DATE ~~R~~ Oct.31/02**V2500-A1/A5/D5 PROPULSION SYSTEMS SERVICE BULLETIN**

This document transmits Revision 3 to Service Bulletin EV2500-72-0190

ENGINE - HP TURBINE ROTOR AND STATOR ASSEMBLY - INTRODUCE A NEW STAGE 1 HPT AIR SEAL
AND A NEW NO. 4 BEARING REAR COOLING DUCT ASSEMBLY

Before and After views of configuration changes that affect the High Pressure Turbine Rotor and Stator Assembly (Stage 1 HPT Air Seal)
Figure 1 (Sheet 1)

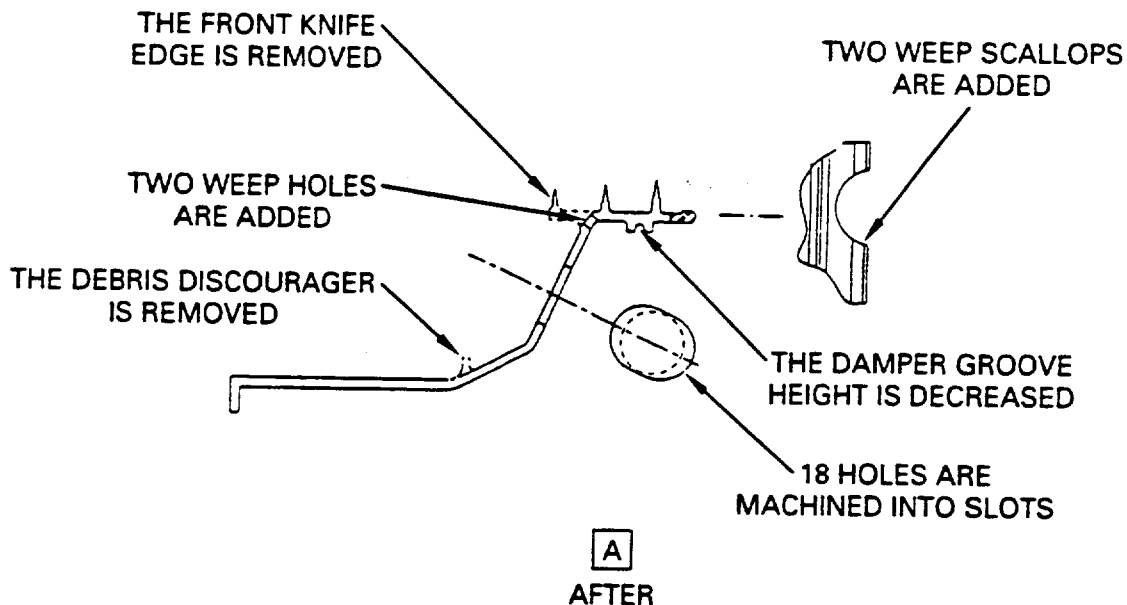
The Stage 1 HPT Air Seal features include: Removal of the front knife-edge, additional drain holes, an elongated cooling air hole and a damper groove with a decreased wall height.

R (1) Improve the features of the parts listed so that more of the unwanted oil will drain from the area between the air seal and the Stage 1 Hub. See Figure 1. The affected parts are:

Before and After views of configuration changes that affect the High Pressure Turbine Rotor and Stator Assembly (No.4 Bearing Rear Cooling Duct assembly)
Figure 1 (Sheet 2)

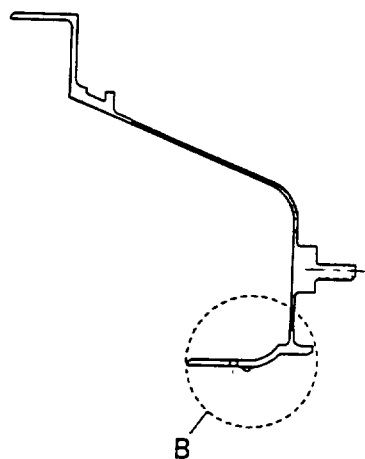
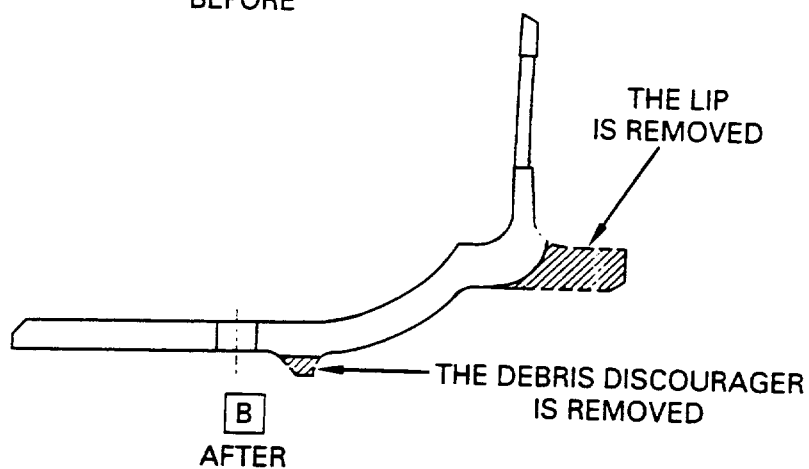
The No. 4 Bearing Rear Cooling Duct Assembly features include: Removal of the debris deflector and the lip adjacent to the Stage 1 Turbine Seal.

THE LIP
IS REMOVED

THE DEBRIS DISCOURAGER
IS REMOVED

Location of the Stage 1 HPT Air Seal
Figure 2

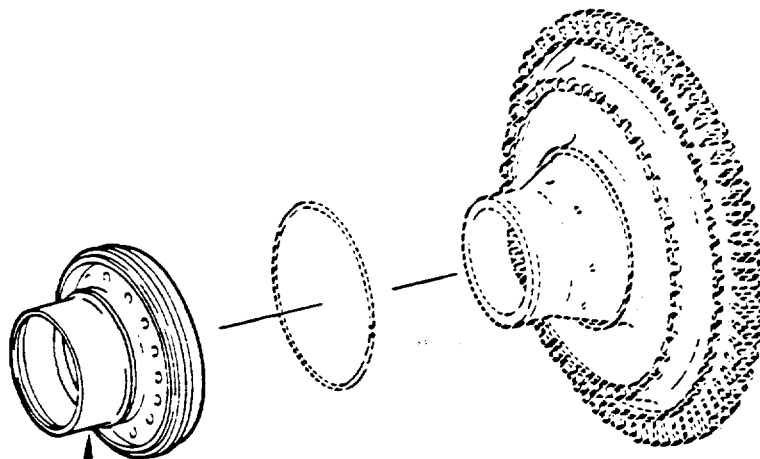
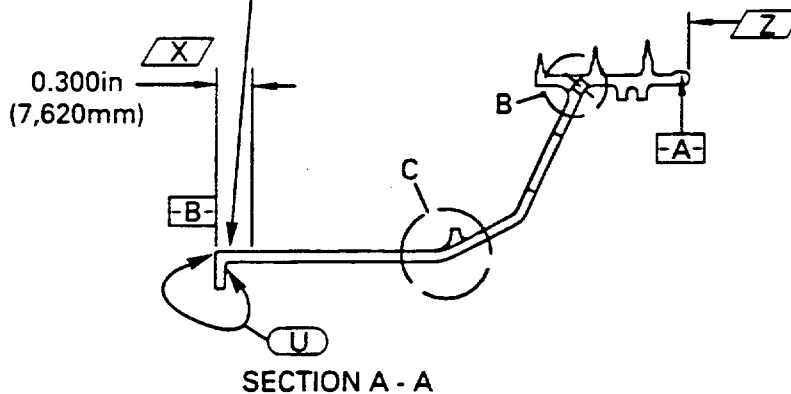
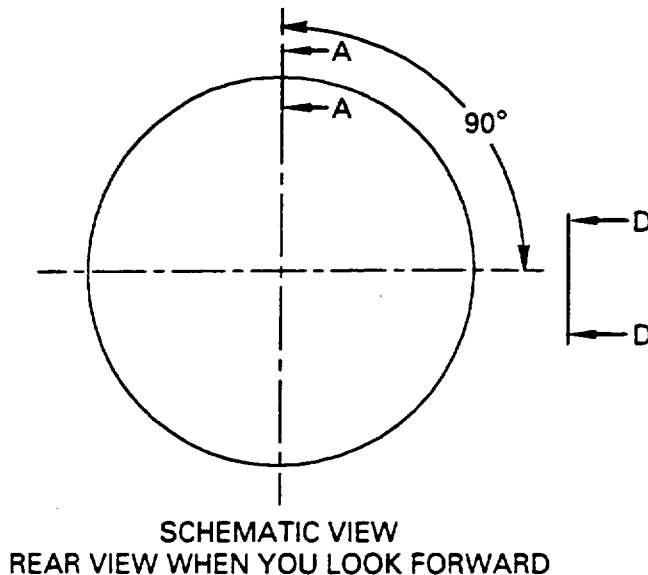
- (1) Install the 2A3069 Stage 1 HPT Air Seal (1 off) by the approved procedure given in Reference (4), Chapter/Section 72-45-10, Assembly. See Figure 2.
- (2) Identify the Stage 1 HPT Rotor Assembly as 2A8421-001 or 2A8821, as applicable. Use the vibration peen method. Refer to the procedure specified in Reference (3), Chapter/Section 70-09-00, Marking of Parts.
- (3) Install the 2A3078-01 No.4 Bearing Rear Cooling Duct Assembly (1 off) by the instructions given in Reference (4), Chapter/Section 72-00-43, Installation. See Figure 7.

INSTALL THE 2A3069
STAGE 1 HPT AIRSEAL
(1 off)

Modification of the Stage 1 HPT Air Seal
Figure 3 (Sheet 1)

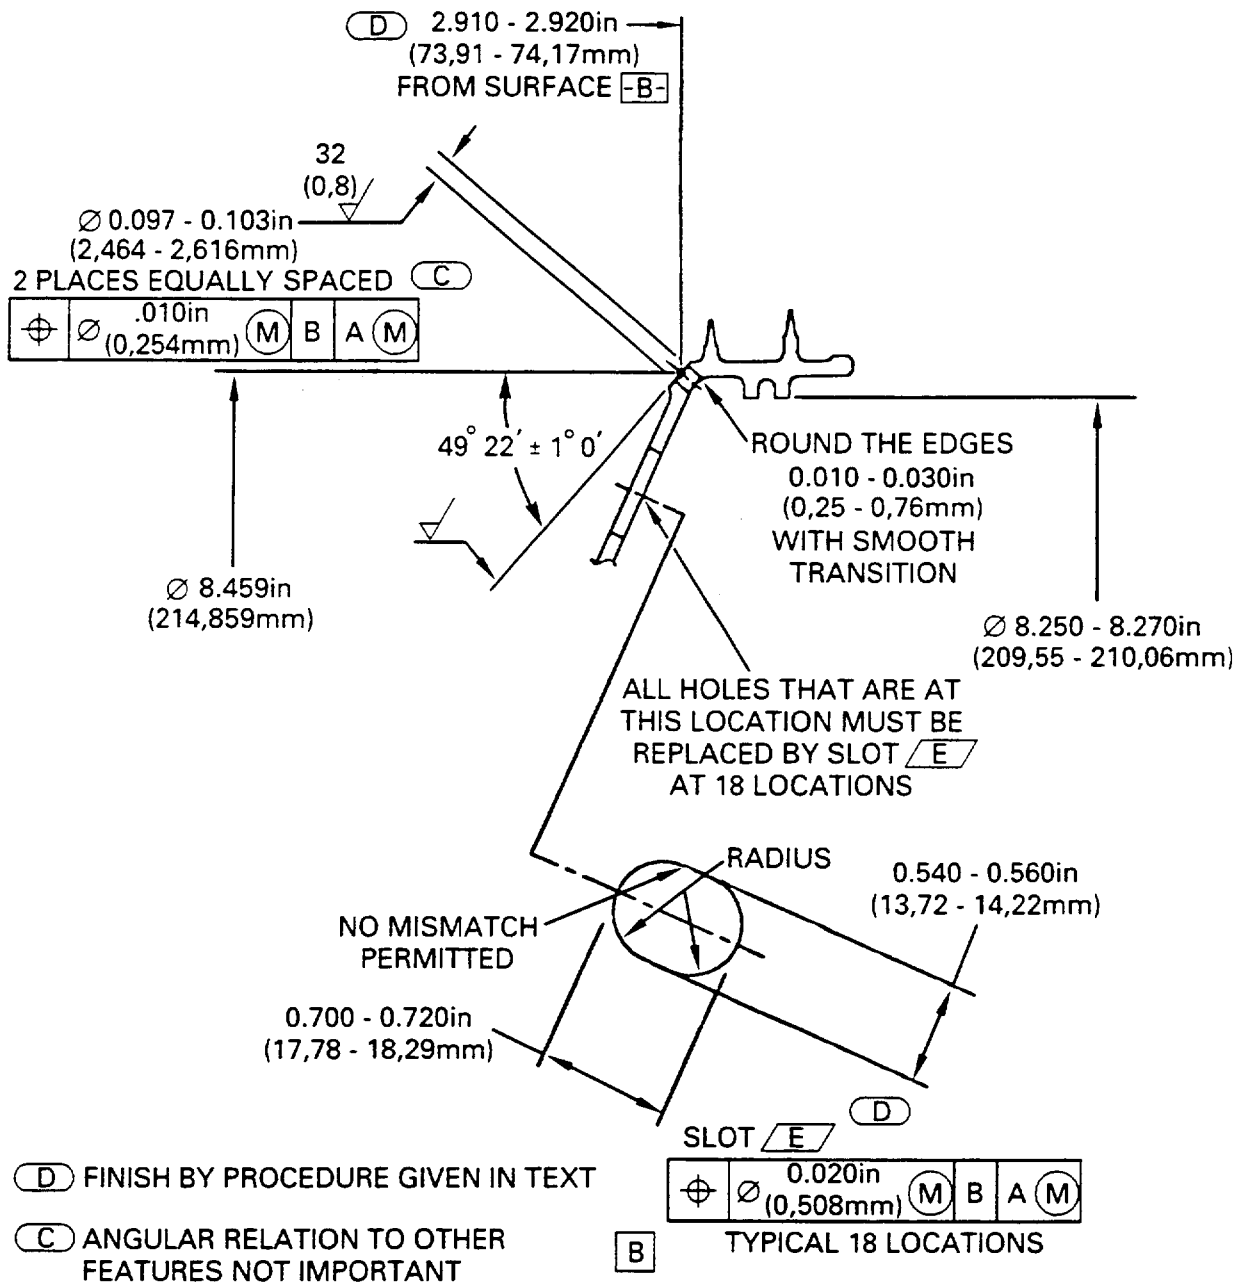
- (b) Machine to remove the front knife edge seal. Finish as specified Refer to Figure 3. See Reference (3), Control No./TASK No. 70-35-09-350-501.
- (c) Machine two holes at the locations given. Hold to the dimensions and finish specified Refer to Figure 3. See Reference (3), Control No./TASK No. 70-35-09-350-501.

- (d) Machine to remove the debris discourager. Hold to the dimensions and finish specified Refer to Figure 3. See Reference (3), Control No./TASK No. 70-35-09-350-501.

DO A CHECK OF THE BALANCE
AT 900 RPM. MAKE A MARK
AT THE POINT OF MOST
UNBALANCE (Heavy side) WITH THE
SYMBOL Δ IN DISTANCE $\square X$
MAKE A RECORD OF THE AMOUNT
OF UNBALANCE IN OZ - IN (gmm)
ADJACENT TO THE SYMBOL Δ

$\square U$ ELECTRICAL CONTACT IS PERMITTED
ONLY IN THIS AREA NO BURNS PITS
OR SELECTIVE ATTACK PERMITTED

Δ MAKE A MARK TO SHOW THE PART NUMBER
SEE TEXT

UNLESS DIFFERENTLY SPECIFIED ALL MACHINED SURFACES ARE (2,25) $\sqrt{90}$
SEE TEXT

Modification of the Stage 1 HPT Air Seal
Figure 3 (Sheet 2)

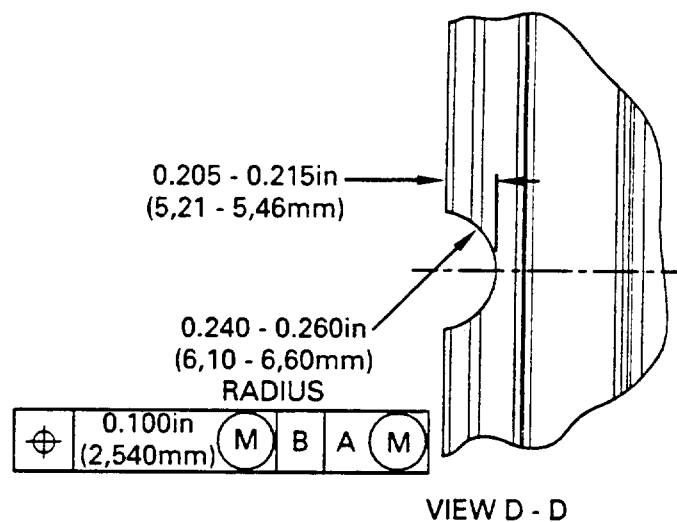
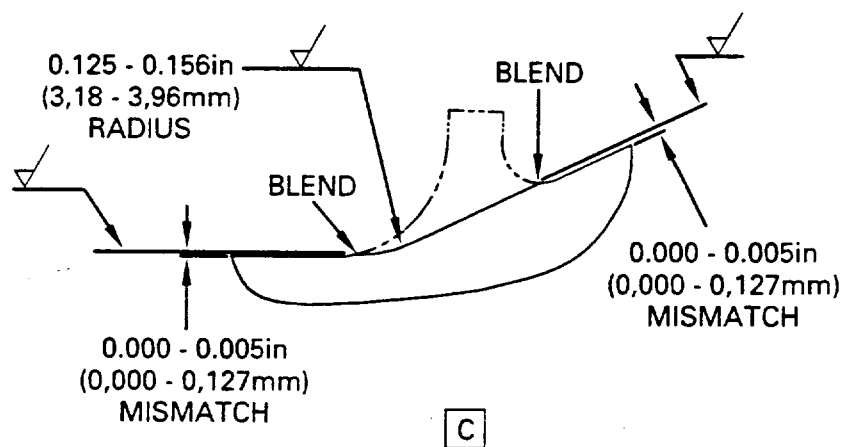
| (b) Machine to remove the debris deflector. Hold to the dimensions and finish as specified | Refer to Figure 3. See Reference (3), Control No./TASK No. 70-35-09-350-501. |
| (c) Machine to install the slots as shown | |

Location of the No.4 Bearing Rear Cooling Duct Assembly
Figure 4

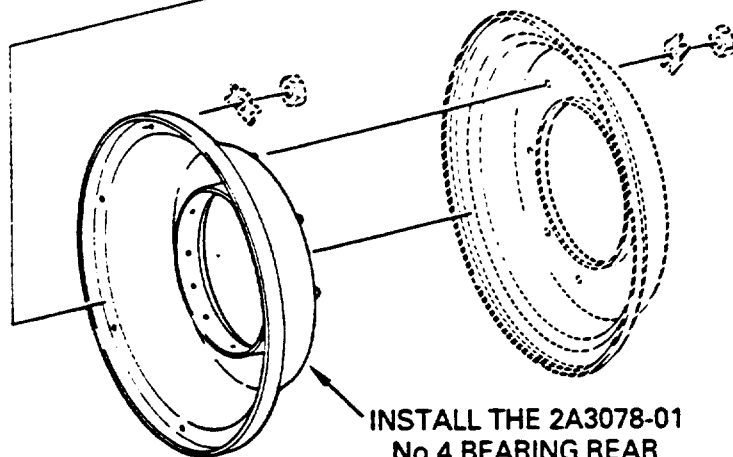
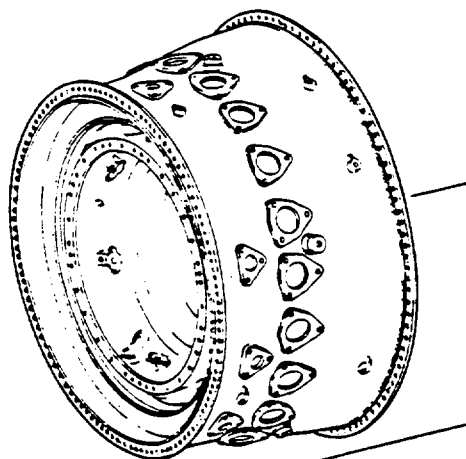
- (1) Install the 2A3078-01 No.4 Bearing Rear Cooling Duct Assembly (1 off) by the instructions given in Reference (4), Chapter/Section 72-00-43, Installation. See Figure 7.

INSTALL THE 2A3078-01
No.4 BEARING REAR
COOLING DUCT ASSEMBLY
(1 off)

Modification of the No.4 Bearing Rear Cooling Duct Assembly
Figure 5

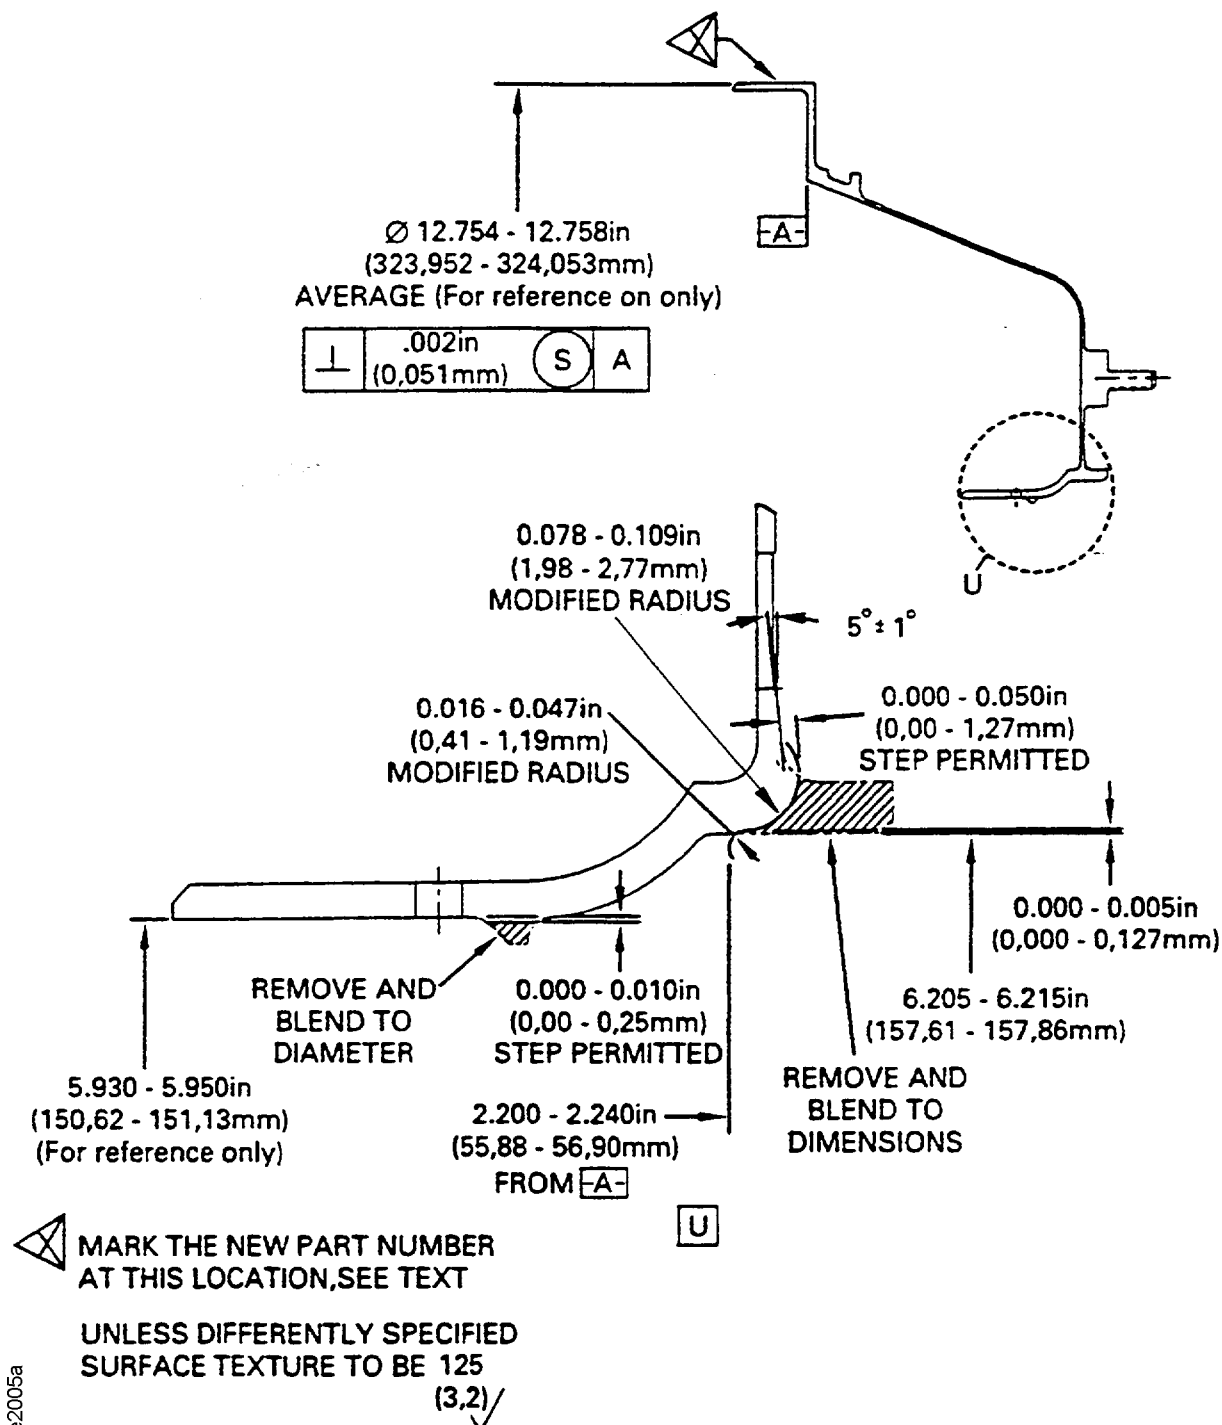
PROCEDURE	RELATED DATA
(a) Set-up and machine to the dimensions specified	Refer to Figures 4 and 5.
(b) Machine to remove the debris deflector	
(c) Machine to remove the lip	
(d) Fluorescent penetrant inspect by SPOP 62. No cracks are permitted	Refer to the procedure given in Reference (3), Control No./TASK No. 70-23-01-230-501.
(e) Mark the new part number adjacent to the old part number. Use the vibration peen method	See Reference (3), Control No./TASK No. 70-09-00-400-501. Refer to Figure 5.
	Old Part No. New Part No.
	2A1205-01 2A3078-01

Family Tree - Seal - Air, HPT Stage 1 for A5/D5. Ref. Catalog Sequence No. 72-45-13
Fig. 01 Item 020
Figure 8

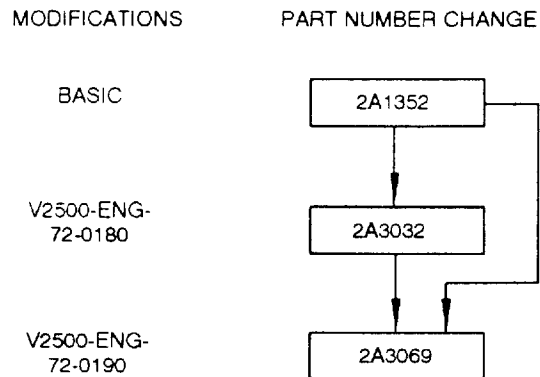
FIG ITEM NO.	NEW PART NO.	QTY	PART TITLE	MAT	OLD PART NO.	INSTR DISP
01020	2A3069	1	...Seal - Air, HPT Stage 1 -		2A1352	(S1)(2D) (E)(G)(I)

FIG ITEM NO.	NEW PART NO.	QTY	PART TITLE	MAT	OLD PART NO.	INSTR DISP
01020	2A3069	1	...Seal - Air, HPT Stage 1 -		2A3032	(S1)(3D) (E)(G)(I)
